February 27, 2017
NND-17-0117
10 CFR 50.90

Virgil C. Summer Nuclear Station (VCSNS) Units 2 and 3
Combined License Nos. NPF-93 and NPF-94
Docket Nos. 52-027 & 52-028

Subject: VCSNS Units 2 & 3: Request for License Amendment: Engineered Safety
Features Actuation Changes for Containment Vacuum Relief (LAR 17-04)

UFSAR Figure 7.2-1, Sheet 19 of 21

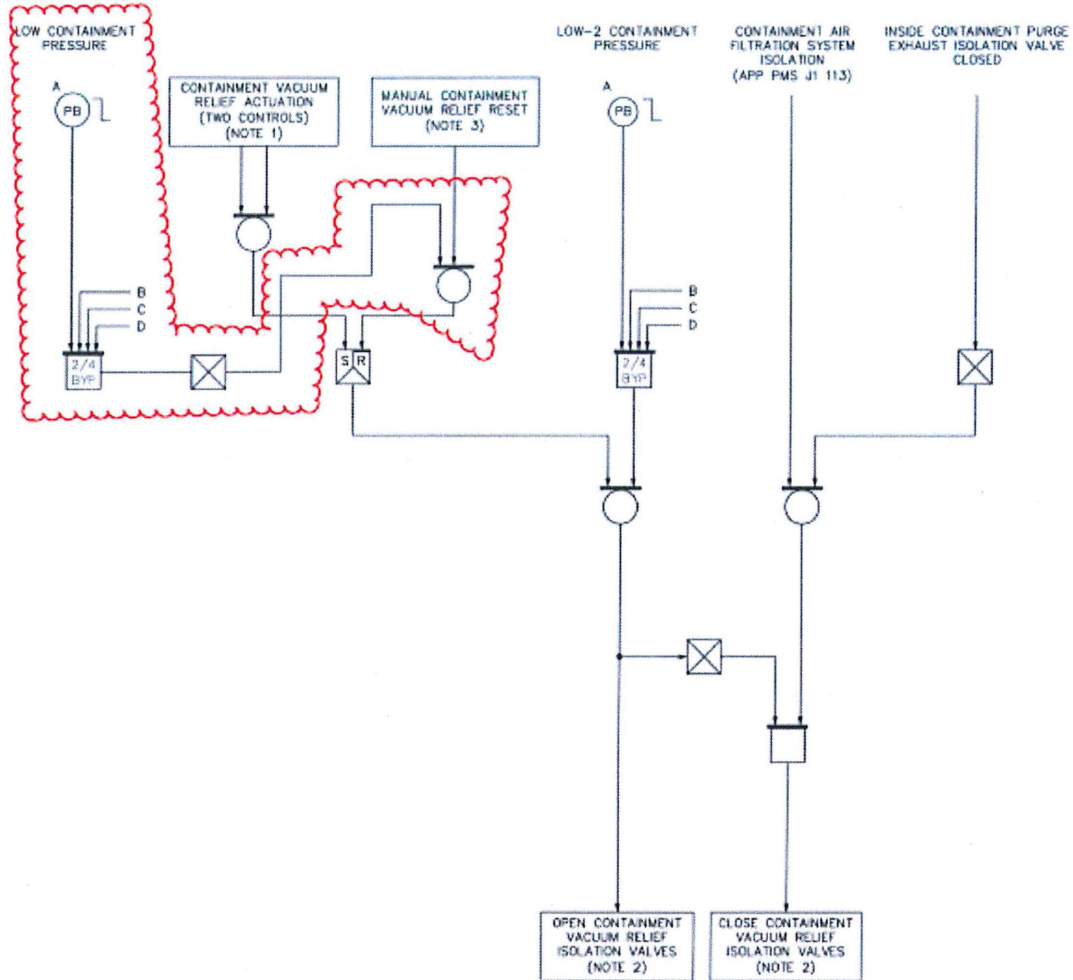
UFSAR Figure 7.2-1, Sheet 19	Revise to reflect the logic change to interlock the Low Containment Pressure signal with the manual initiation.
UFSAR Subsection 7.3.1.2.26	Revise to add description of the manual initiation interlock with two-out-of-four Low Containment Pressure logic and provide automatic reset of the manual initiation function.
UFSAR Table 7.3-1, Sheet 9	Revise Item 28.b - Containment Vacuum Relief, Manual initiation, to reflect a coincident interlock with the Low containment pressure condition.
UFSAR Subsection 9.4.7.1.1	Revise discussion to indicate that manual initiation can be actuated once the Low containment pressure signal is generated.

Condition 2 consists of two momentary controls. Manual actuation of either of the two controls will result in opening of the containment vacuum relief valves. [Manual containment vacuum relief valve actuation for Condition 2 is interlocked to prevent actuation until the Containment Pressure Low setpoint is reached in any two of the four divisions. After manual containment vacuum relief is initiated, the signal is automatically reset when containment pressure rises above the Low setpoint. Following signal reset, the valves will remain open until closed by a manual or automatic actuation signal.](#)
